Figure 1 Reversible
Exchange with Stream

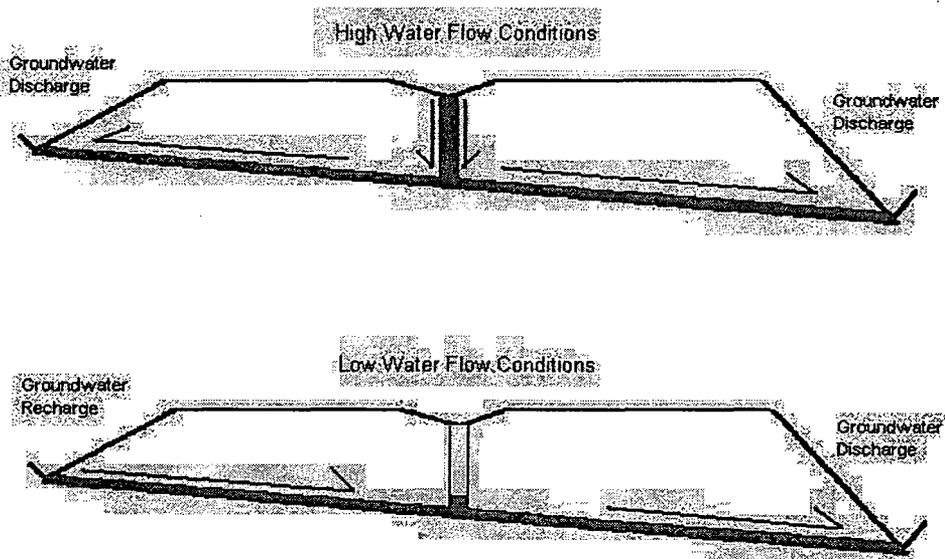
The deficiency in the surface water gauging and staging tasks is that the premise of the current conceptual model is that there *is* karst flow underlying the JPG DU site. The objective of the characterization is the same, *i.e.*, provide the fate and transport modeling with an accurate description of how much groundwater flow is carrying how much DU how quickly from the impact area to the locations of potential exposure. But, groundwater no longer is conceptualized as simply moving toward and into the local

streams, driven by in-basin topography. A karst network may discharge groundwater to the local stream. But, a karst network may recharge with water taken from the local stream, transport it through the karst system of the bedrock and discharge it back to the stream downstream of the surface water monitoring network. A karst network may also recharge with water taken from a local stream and discharge it to a stream in an entirely different basin. Karst groundwater and DU in or transported by that groundwater is undetectable by a gauging and staging system designed for non-karst hydrogeology when the karst system which actually exists discharges outside the confines of the surface water monitoring system.

This deficiency is further complicated because the interaction of a karst network and surface water drainage can and often does change temporally. Figure 1 shows a schematic of a simple karst network and how it can change with respect to its impacts on streams that it intersects. During high recharge conditions, groundwater in the karst network is recharged from precipitation and discharges to both streams. However, during low water flow conditions, the karst system recharges from precipitation and from the stream with the higher elevation and discharges only to the lower stream. Stream-flow separation of gauging data on either stream will produce an erroneous interpretation of the aquifer recharge unless the location and the transient nature of the karst interaction are known. The gauging and staging tasks proposed in the FSP and related addenda cannot account for even such a simple transient interaction and cannot, therefore, provide the data to the fate and transport model that is needed.

A.037 The stream/cave gauging and stream staging activities in the modified FSP are not designed to document and quantify groundwater and surface-water interactions. Such a design is fundamentally needed to generate the data that are meaningful to the fate and transport modeling required to support site decommissioning. Achieving a design capable of supporting a decision on site decommissioning will require work not presently in the modified FSP.
